**From:** PUBCOMMENT-OCC  
**Sent:** Friday, March 17, 2023 8:38 AM  
**To:** PUBCOMMENT-OCC2; PUBCOMMENT-OPIC; PUBCOMMENT-ELD; PUBCOMMENT-WQ  
**Subject:** FW: Public comment on Permit Number WQ0015918001

**REGULATED ENTY NAME** COTTON CENTER MARTINDALE WWTP

**PERMIT NUMBER:** WQ0015918001

Re: Notice of Public Meeting  
Permit No. WQ0015918001  
Walton Texas, L.P.

Figure 2-1  
**WELLHEAD PROTECTION AREA  
MARTINDALE  
PWS ID NO. 0280013**

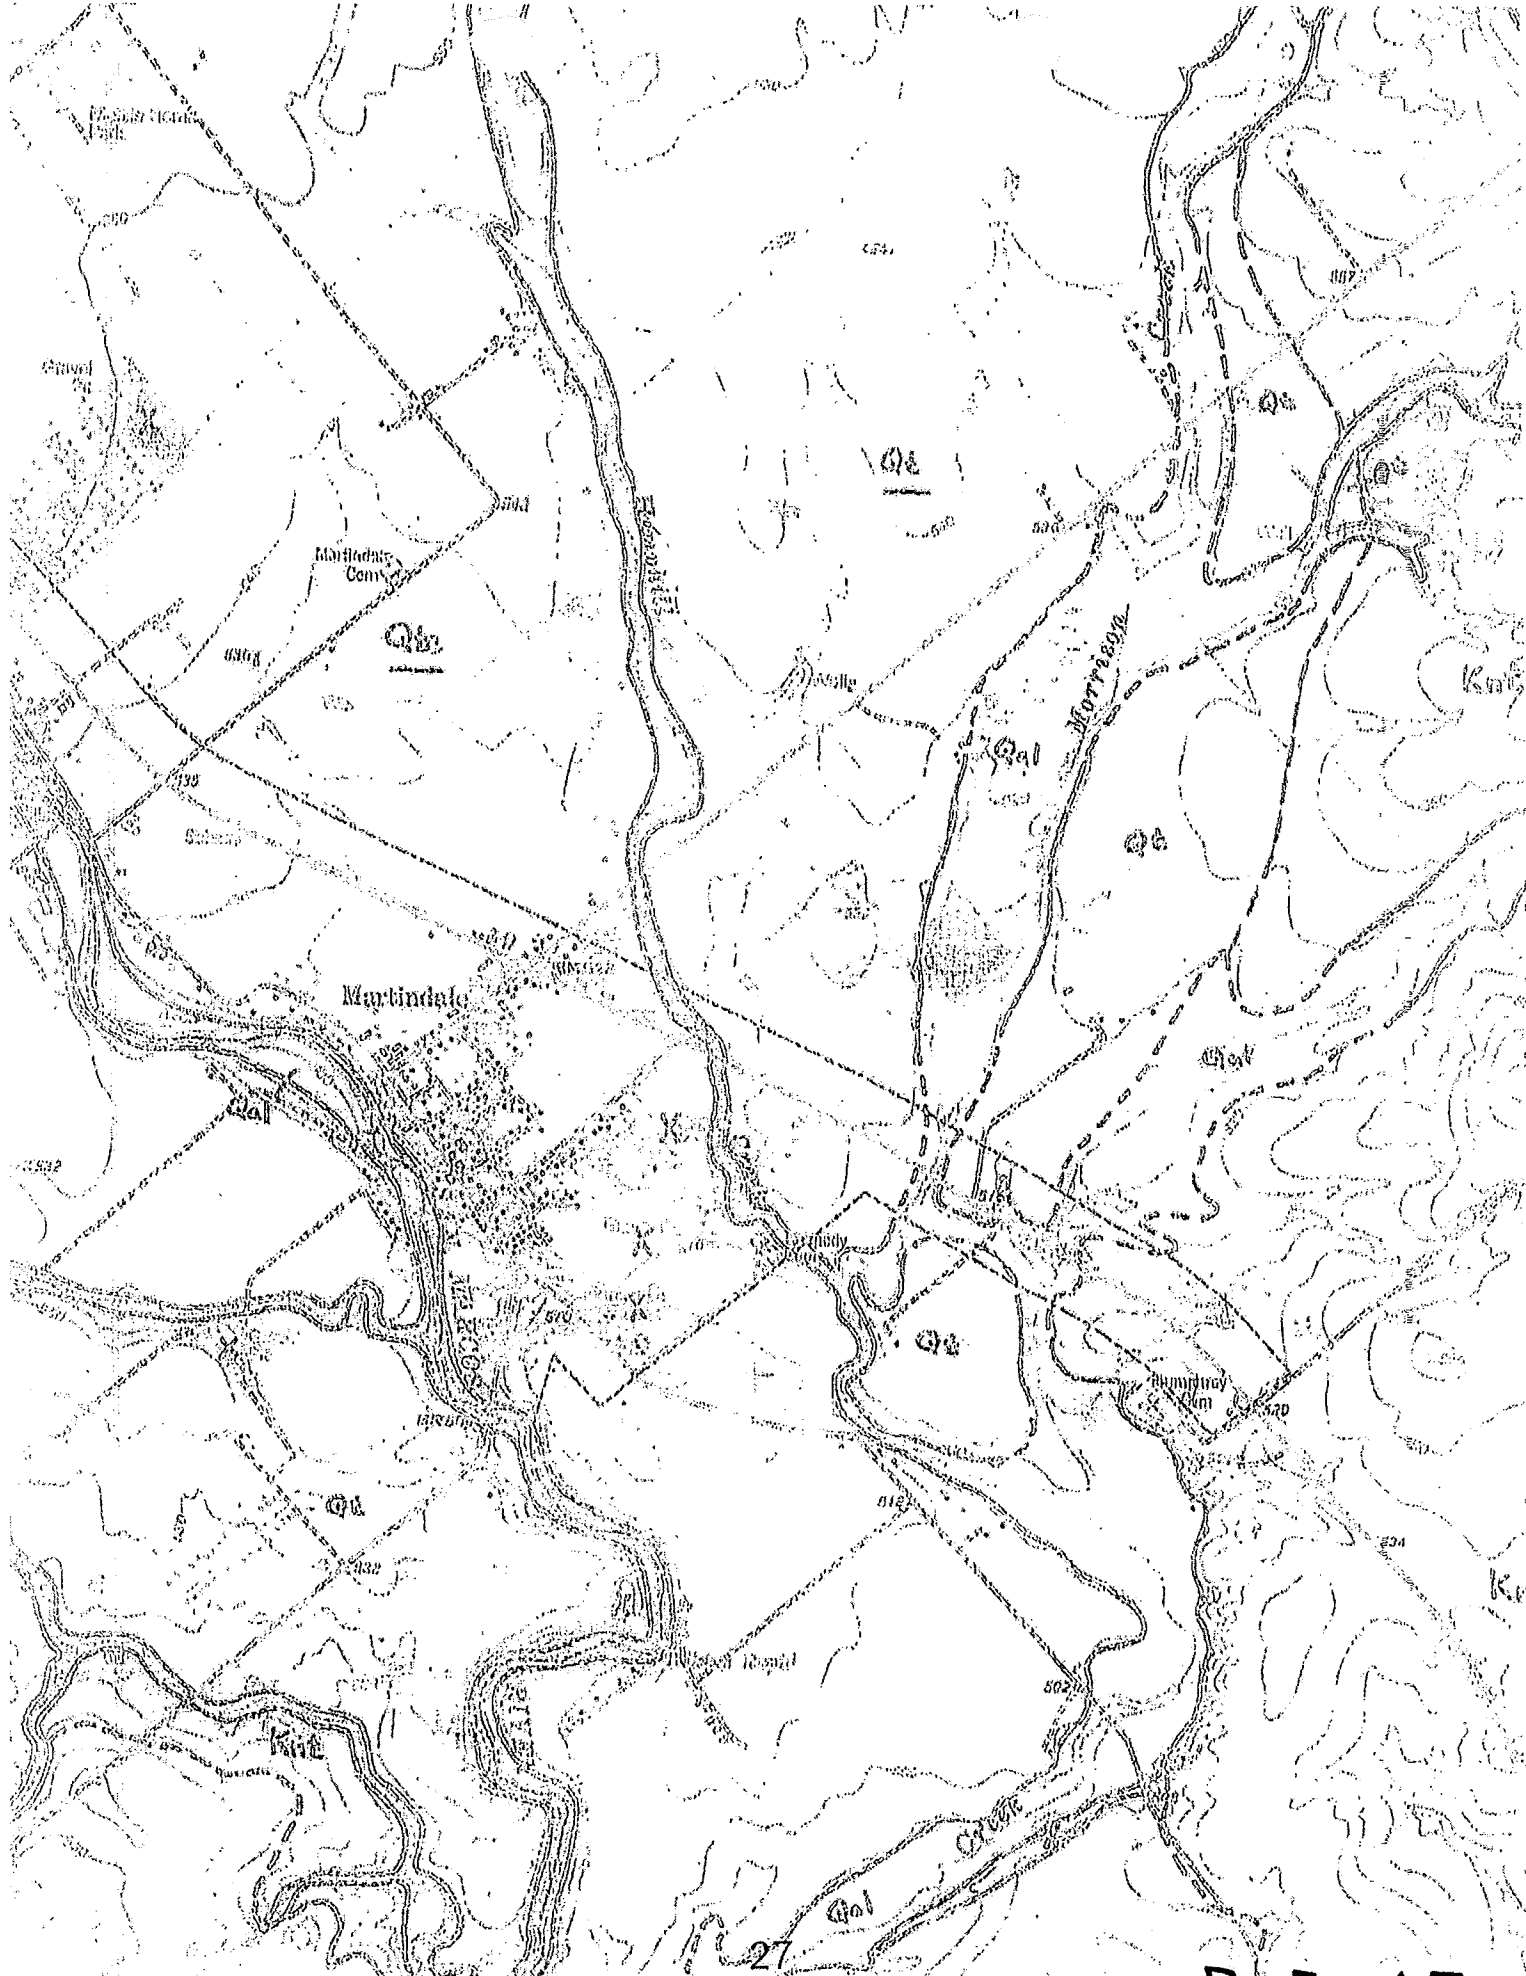
The Martindale WSC operates 3 public drinking water supply wells within one mile (Approx.) of the proposed discharge. Please see the attached wellhead protection area map. The well protection area closely bounds Hemphill Creek, the proposed receiving stream for the partially treated discharge. The Water Corporation had only two active wells at the time this map was produced. The source water for these three wells is groundwater from a recent Pleistocene alluvium formation which is bisected by Hemphill Creek. The potential for partially treated wastewater to commingle or enter this water bearing formation is high, thereby possibly degrading the existing groundwater quality.
